IMPORTANT SAFETY RECALL

NHTSA Safety Recall No. 18V343

Customer Service Notice

Receiver Hitch Inspection and Placard Installation

Figure 1 — Tow Weldment Inspection, Type 1

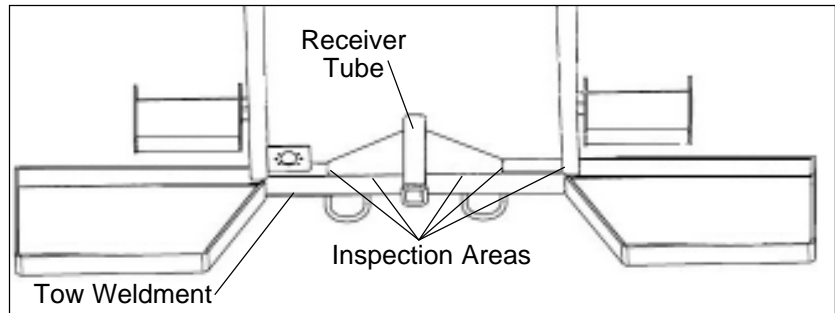
2. **Class III Hitch:** Two types of tow weldment installations are standard. There may be others determined by customer preference. Inspect the tow weldment for any cracks or deformed areas (refer to Figure 1 or Figure 2). Look at the welds at the corners and the receiver tube mounting on both sides of the tow weldment and the receiver tube. Also inspect the underside of the weldment/

4. If there is any evidence of damage, cracks, or deformed parts, the tow weldment and receiver tube must be replaced for either type. **Do not attach anything to the hitch or tow a trailer until the weldment is replaced.** Contact Altec Technical Support by calling 1-877-GO ALTEC (1-877-462-5832) and select Prompt 4 for help to get the necessary parts.

5. If no cracks or deformation is found, install the Class Three Reinforcement Kit, P/N 970748064, for the Type 1 tow weldment no later than 90 days after the inspection. No reinforcement kit is required for Type 2 tow weldments.

Figure 3 — Inspecting Receiver Tube

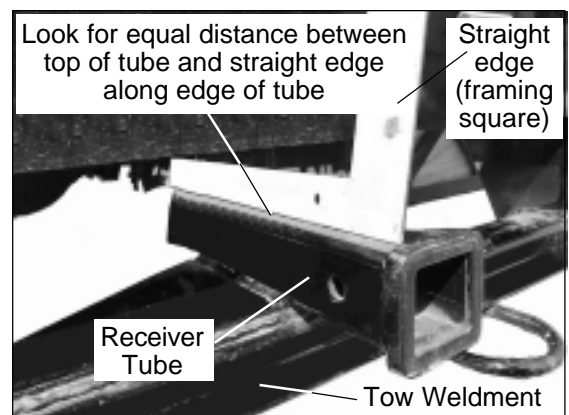
3. Use the straight edge or level to see if the receiver tube is straight or deformed (refer to Figure 3).

Do not allow the hitch to be overloaded - 600 lb. vertical load and 6000 lb. towing capacity.

Figure 4 — Class V Inspection

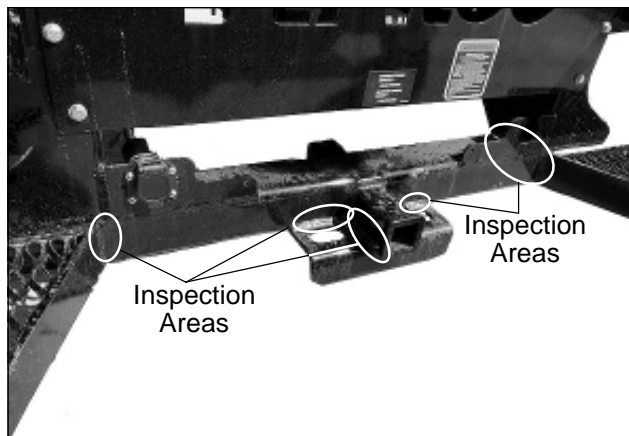
7. **Class V Hitch:** Look at the welds at the corners and the receiver tube mounting on both sides of the tow weldment and the receiver tube (refer to Figure 4).

9. If there is any evidence of damage, cracks, or deformed parts, the tow weldment and receiver tube must be replaced. **Do not attach anything to the hitch or tow a trailer until the weldment is replaced.**

8. If no cracks or deformation is found, no reinforcement is necessary. Add placards as described in Class III and Class V Placard Installation below.

Figure 5 — Placard Installation

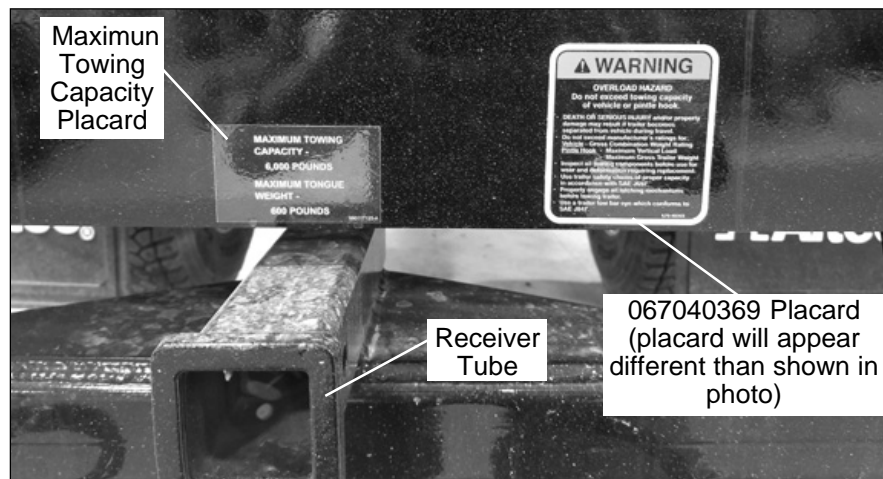
1. Install the placards included with the CSN (refer to Figure 5) on the rear of the body above the receiver hitch.
